**TECHNICAL SERVICE BULLETIN****3.5L PowerBoost - Lariat/XLT/XL Trim Levels - Right Side Turbocharger Concerns****24-2264**23 August
2024**Model:**

Ford	Engine: 3.5L PowerBoost
2024 F-150	Lariat/XLT/XL trim level

Figure 1

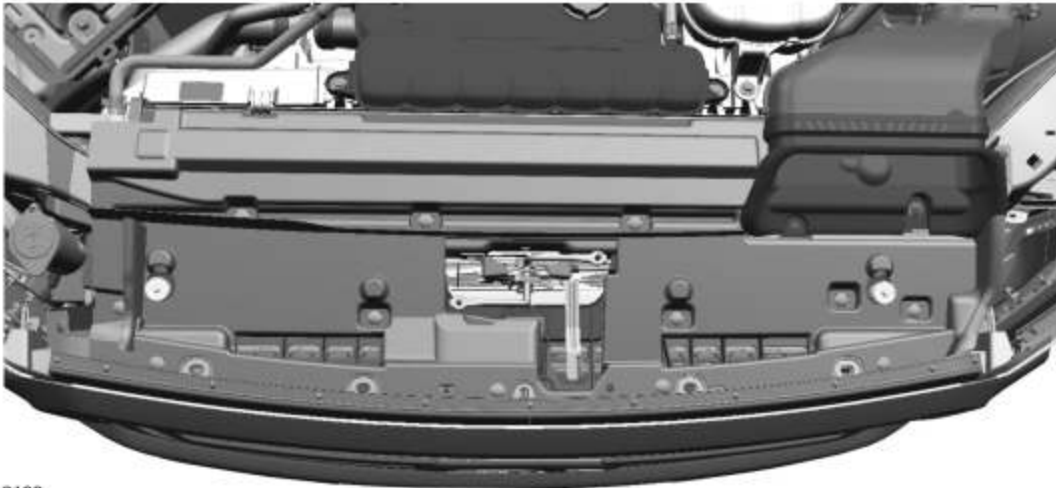
1. Does the upper air deflector match the one outlined in Figure 1?

(1). Yes - proceed to Step 2.

(2). No - this article does not apply. Refer to the WSM for additional diagnostics.

Figure 2

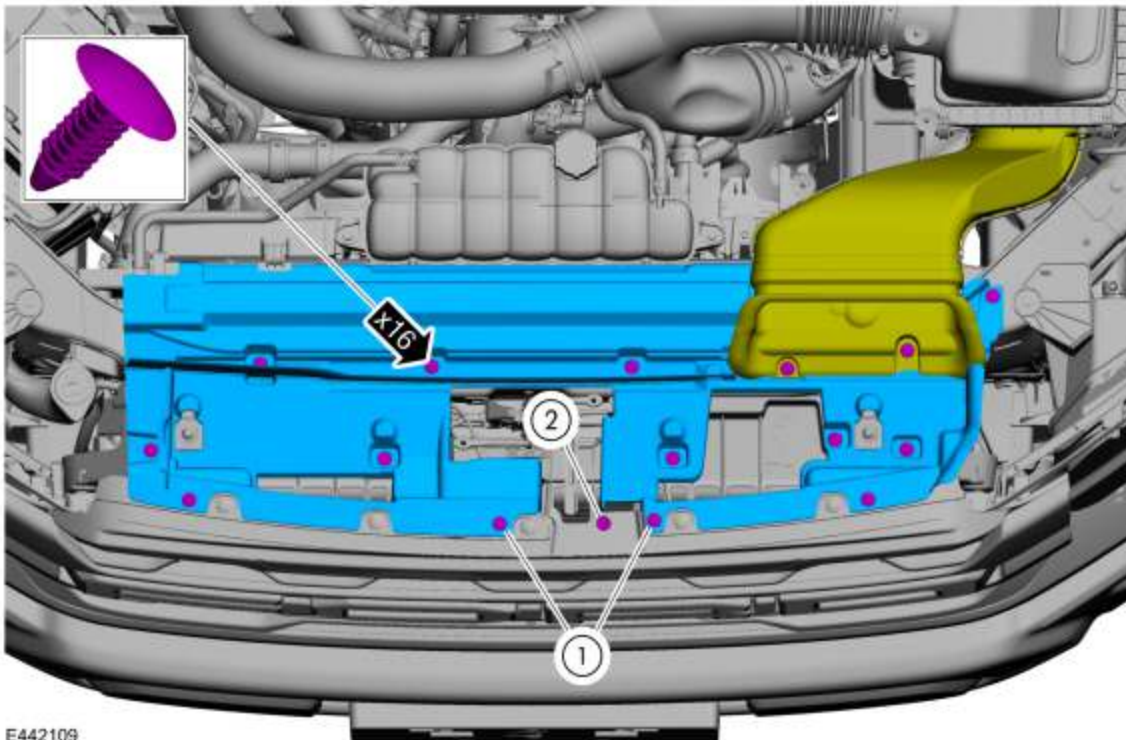
2. Remove and discard the upper radiator air deflector and the 15 air deflector push pin retainers. (Figure 2)

(1). Set the new air deflector in place and install 13 pin retainers except for the 2 shown in Figure 2, Callout 1 and the 1 shown in Figure 2, Callout 2

(2). Using the 2 remaining holes in the newly installed air deflector as a guide, use a 1/4 in. (6.5 mm) drill bit and drill a hole through the radiator grille at each location shown in Figure 2, Callout 1.

(3). Install the remaining 2 pin retainers to secure the air deflector in place.

(4). Install a single pin retainer in the now exposed hole in the grille as shown in Figure 2, Callout 2.
